# Rezoning Transportation Analysis

Petition Number: 2021-114

## Revision Log:

Date	Description
09-15-21	First Review (BKB)
10-18-21	Second Review (AO)

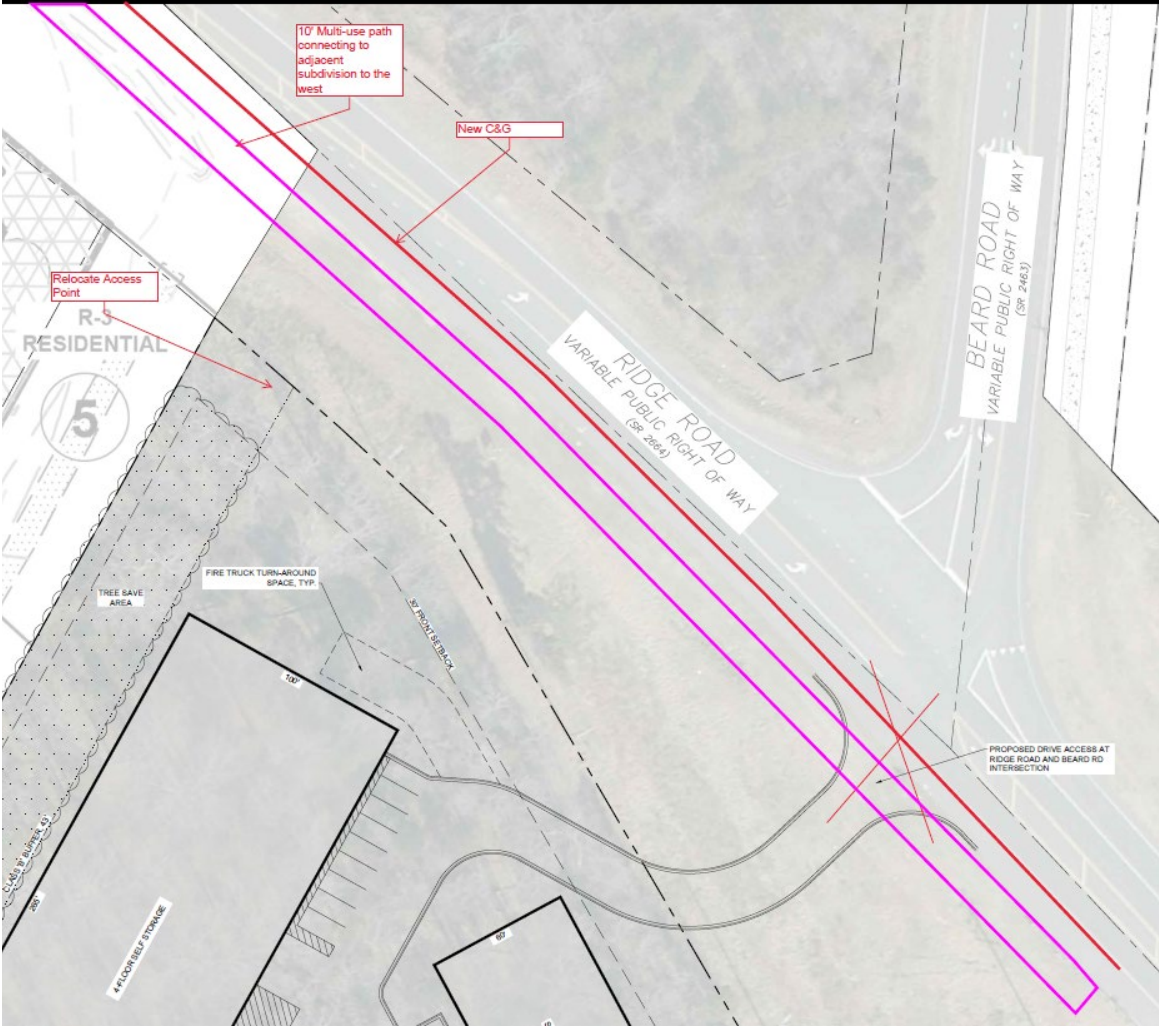
1. **Curblines:** The proposed zoning district has a setback measured from back of the existing or proposed future curblines.
  - a. **Ridge Road:** Provide curb and gutter along existing edge of travel lane along the entire property frontage. Use existing edge line for placement of gutter.

Label and dimension the curb and gutter from the centerline for Ridge Road on the site plan.

**Clarifying Comment from 9-15-21: Place curb and gutter off of edge of travel lane, not existing edge of pavement. Dimension the curb and gutter from the centerline of Ridge Road.**

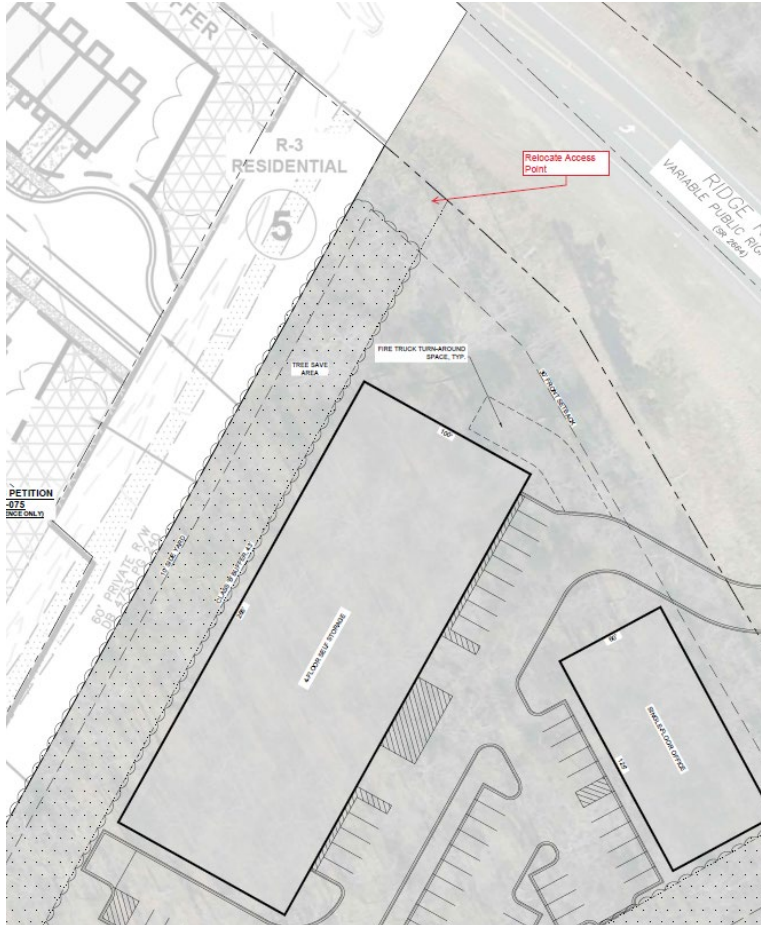
4. Site plan and revisions are needed to reflect the access point to the development on the western portion of the property per the below image. The existing Ridge Road and Beard Road intersection would require improvements that aren't commensurate with the development, so this relocated driveway will require less improvements of the developer within Ridge Road.
